Access Compliance Report

Public Rights-of-Way

Intersection ID: 44778	Main Street: SILVER_CRESCENT_DR	Cross Street: VENDOME_ST	Location:	N
ADA ID: 9D7DE13F9688	Ramp Type: Directional1	Initial Pass/Fail: Fail	Overall Compliance: No	Severity Score: 1.25
Codes/Mitigation Info/Possible Solution		Field Measurements/Component Compliance

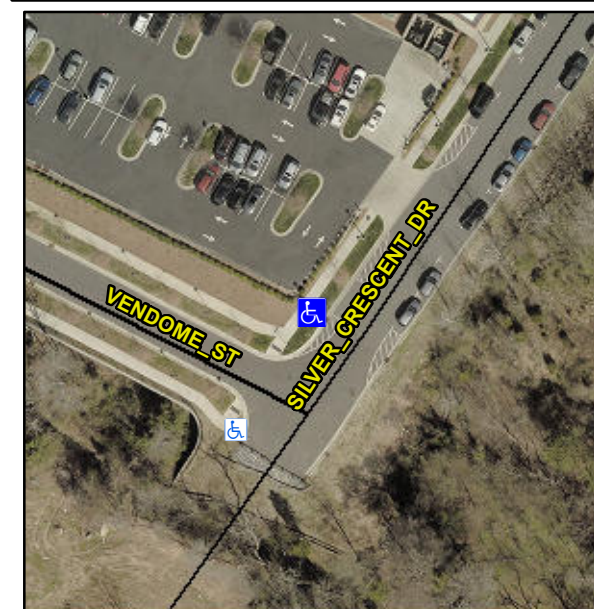
R304.5.3

Compliance	Description	Data	Compliance	Description	Data
N/A	Ramp Length (in)	93.0	N/A	Grade Break?	N/A
Yes	Ramp Width (in)	70.0	N/A	Grade Break Slope (%)	0.0
Yes	Ramp Slope (%)	6.1	N/A	Grade Break XSlope (%)	0.0
No	Ramp XSlope (%)	2.9			
N/A	Flare Type LT	N/A	N/A	Flare Type RT	N/A
N/A	Flare Slope LT (%)	N/A	N/A	Flare Slope RT (%)	0.0
N/A	Flare Traversable LT?	N/A	N/A	Flare Traversable RT?	N/A
N/A	Landing Length (in)	0.0	N/A	DWS Provided?	N/A
N/A	Landing Width (in)	0.0	N/A	DWS Contrast?	N/A
N/A	Landing Slope (%)	0.0	N/A	DWS Length (in)	N/A
N/A	Landing X Slope (%)	0.0	N/A	DWS Full Width?	N/A
N/A	Landing Curb? (Y/N)	N/A	N/A	DWS Offset LT (in)	N/A
N/A	Shared Landing?	N/A	N/A	DWS Offset RT (in)	N/A
N/A	Gutter Ponding?	0.0	N/A	Gutter Slope (%)	N/A
N/A	Gutter Lip Ht (in)	0.0	N/A	Gutter X Slope (%)	N/A
N/A	Painted X Walk1?	No		Road Slope (%)	1.0
	X Walk 1 Direction	To SW		Road X Slope (%)	1.5
	X Walk 1 Width (in)	N/A		Clear Space?	N/A

Remove & Replace Entire Ramp.
